Remarks

The present amendment responds to the Official Action dated September 20, 2004. A petition for a one month extension of time to respond and authorization to charge Deposit Account No. 50-1058 the large entity extension fee of \$120 accompany this amendment. The Official Action objected to informalities in claims 1-22. The Official Action rejected claims 1-22 under 35 U.S.C. 112, second paragraph. The Official Action also rejected claims 1-3, 11-14 and 20-22 under 35 U.S.C. §103(a) based on Womack et al. U.S. Patent No. 5,982,819 (Womack) in view of Ivo et al. "DSP and Digital Down Conversion" Proceedings of the Radioelektronika 99, pp. 225-228 (Ivo). The Official Action rejected claims 4-6 and 15-17 under 35 U.S.C. §103(a) based on Womack in view of Ivo and further in view of Thacker U.S. Patent No. 6,011,548 (Thacker). The Official Action also rejected claims 7-10 and 18-19 under 35 U.S.C. §103(a) based on Womack in view of Ivo and further in view of Tourtier U.S. Patent No. 5,446,495 (Tourtier). These grounds of rejection are addressed below. Claims 1-9 and 11-22 have been amended to be more clear and distinct and new claims 23 and 24 have been added. Claims 1-24 are pre

FIGURE 1

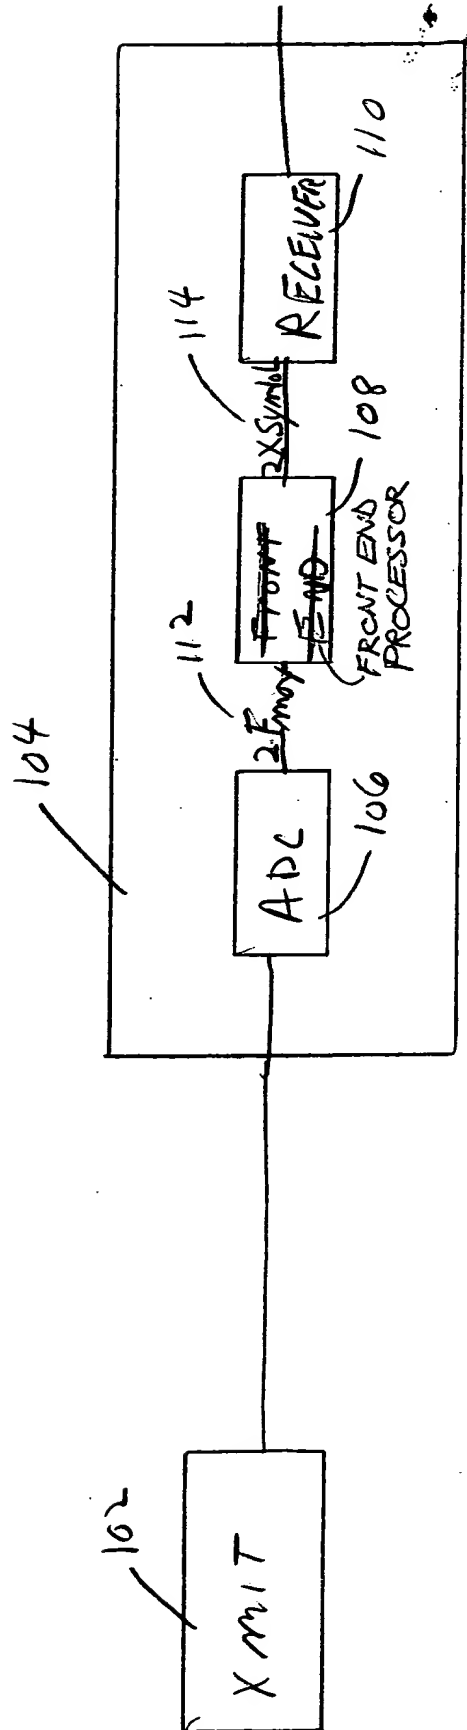
The paragraph beginning on page 7, line 11 has been amended to correct an incomplete sentence so as to properly reference the two main elements of Figure 1. The sentence beginning on line 15 "In an illustrative embodiment, the system 100 a transmitter 102 and a receiver system 104." is amended to "In an illustrative embodiment, the system 100 includes a transmitter 102 and a receiver system 104."

FIGURE 3

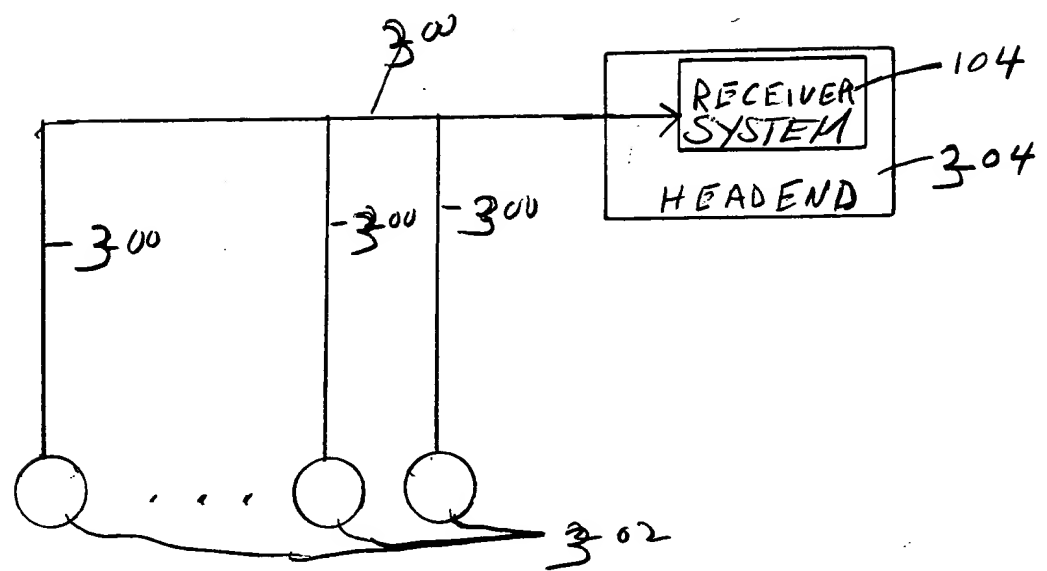
The paragraph beginning on page 9, line 1 has been amended to correct a reference to the system illustrated in Figure 3. The communications system 100 of Figure 1 illustrates a system having a single transmitter 102. In the paragraph beginning on page 9, line 1 reference to system 100 has been amended to reference system 310 consistent with the discussion in the same sentence which addresses a system having multiple transmitters. The system 310 reference is also added to line 10.

FIGURE 6

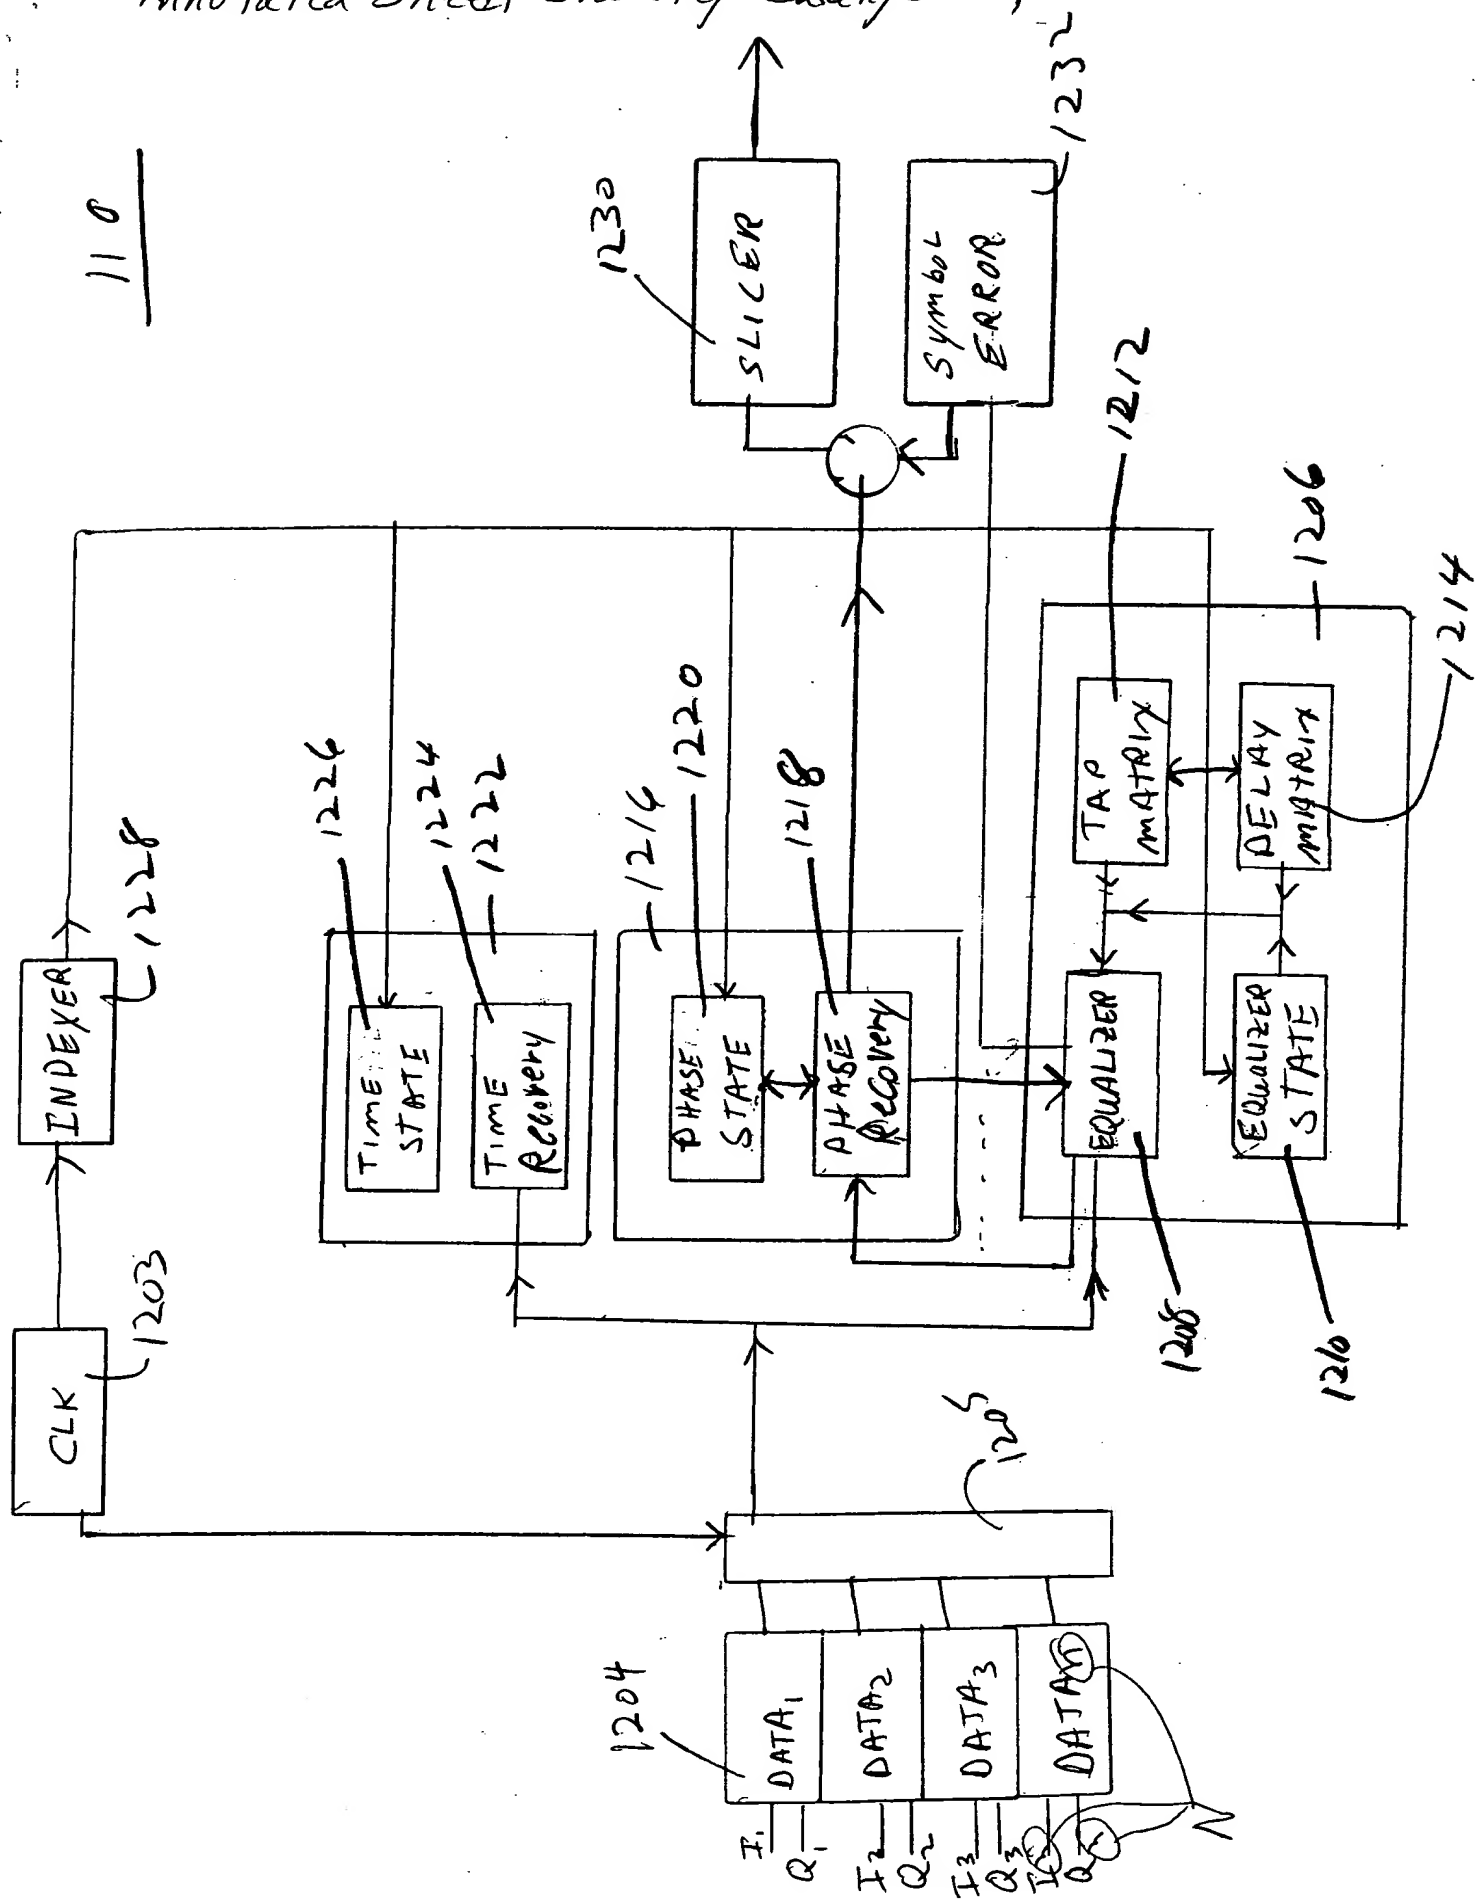
The paragraph beginning on page 11, line 13 has been amended to correct the name of element 600 in Figure 6 from a front end 600 to a front end processor 600. Support for this change can be found in the brief description of the drawings for Figure 6 which states that "Figure 6 is a conceptual block diagram of one embodiment of a front end processor in accordance with the present invention". Further support for this change can be found in the second sentence of this paragraph that begins "The front end processor 600..." and correctly identifies element 600 as a front end processor. Also, the paragraph has been amended to clarify the usage of 102.4 in line 21 to be 102.4 mega-samples per second. Support for this change can be found in the first sentence of this paragraph on page 11, beginning on line 13 where the sample rate of 102.4 mega-samples per second was introduced.

The paragraph beginning on page 14, line 14 has been amended at lines 16 and 17 to change "the front end described in the discussion related to Figure 6" to "the front end processor described in the discussion related to Figure 6" to correctly reference the front end processor in Figure 6 that is discussed on page 11, lines 16-19. A typographical error is corrected in line 19 changing "Such as system" to "Such a system". The reference numbers to the down-converters in Figure 7 have been amended in line 28 changing "converters 728 through 726" to "converters 702 through 726". Support for this change can be found in the preceding paragraph beginning on page 14, line 5 where the down-converters in Figure 7 were introduced.

FIGURE 13

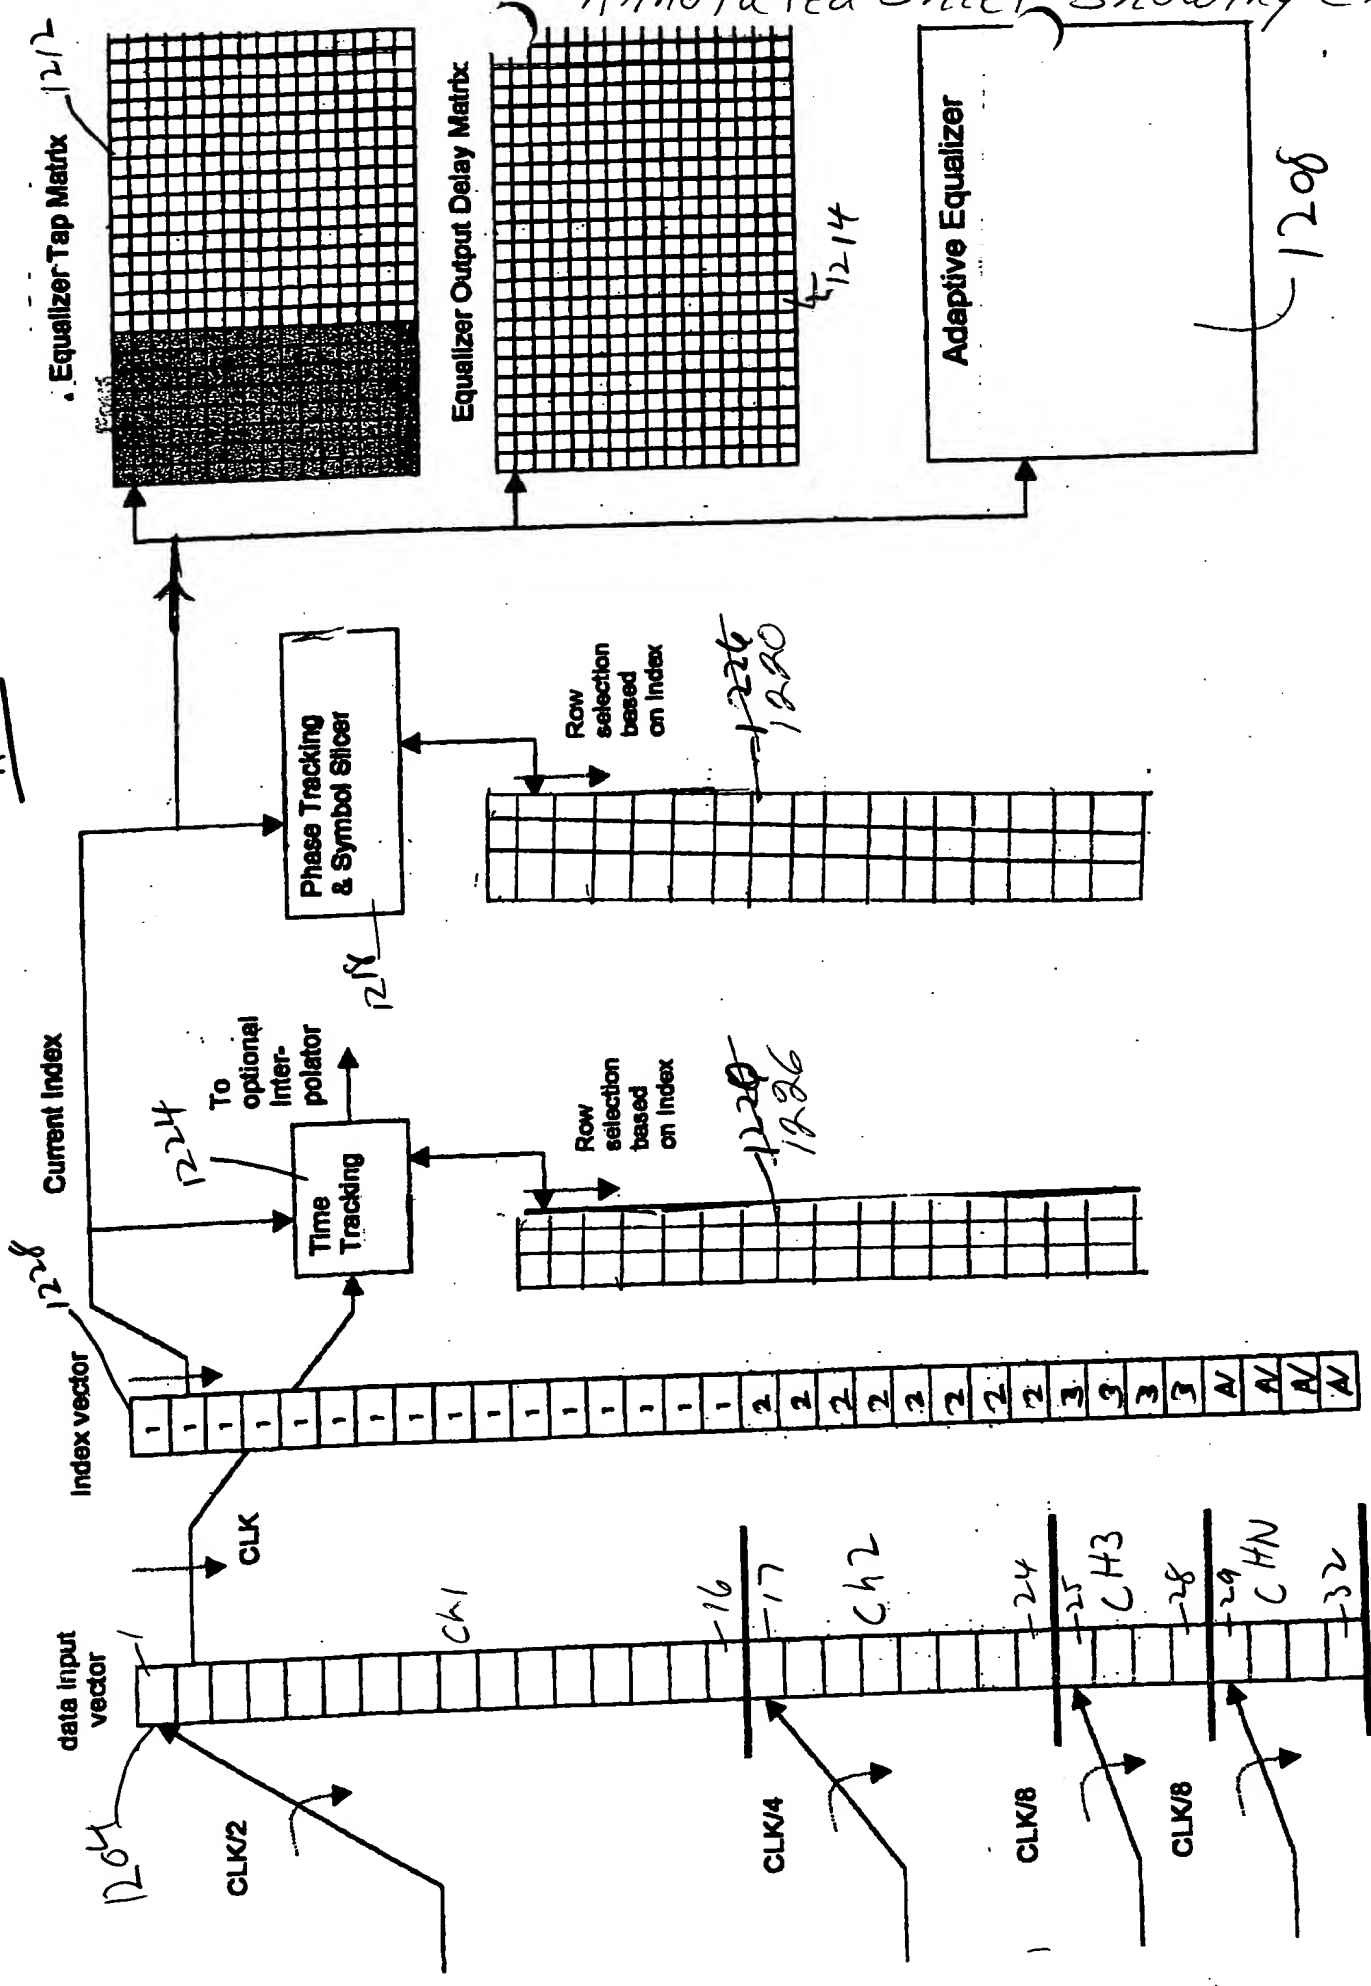
The paragraph beginning on page 21, line 27 has been amended to correct the reference of channel n to channel N as used in Figure 13 in data memory 1204 and generally in the specification for the Nth channel. In line 28 of this paragraph, "channels 1 through "n" respectively" has been amended to "channels 1 through "N" respectively". On page 22, lines 6 and 8 of this paragraph, "three and n" has been amended to "three and N". Support for this change can be found in the paragraph beginning on page 20, line 27 where on page 21 channel N is discussed at lines 7-10.

The paragraph beginning on page 22, line 27 has been amended to change the reference to CH4 to CHN as illustrated in Figure 13 in the context of the discussion on channels 1, 2, 3, and N. For example, in this paragraph on page 23, beginning at line 1, the thirty-two locations of data memory 1204 in Figure 13 are described where "the first sixteen of which are allocated to

channel CH1, the next eight of which are allocated to channel CH2, the next four allocated to channel CH3, and the last four allocated to channel CHN."

The paragraph beginning on page 23, line 7 has been amended to correct an incorrect channel name and incorrect reference numbers. In line 8 of this paragraph, CH4 has been changed to CHN to properly reference the use of CHN in Figure 13. The references to elements 1218, 1220, and 1226 has been corrected in the description to be consistent with the elements labeled 1218, 1220, and 1226 in Figure 12 and Figure 13. In lines 10 and 11, "the phase tracking loop 1226" has been changed to "the phase tracking loop (phase recovery) 1218". In line 15, "the time tracking loop vector 1220" has been changed to "the time tracking loop vector 1226". In line 18, "the phase tracking loop vector 1226" has been changed to "the phase tracking loop vector 1220" and in line 23, "phase tracking loop state vector 1226" has been changed to "phase tracking loop state vector 1220".
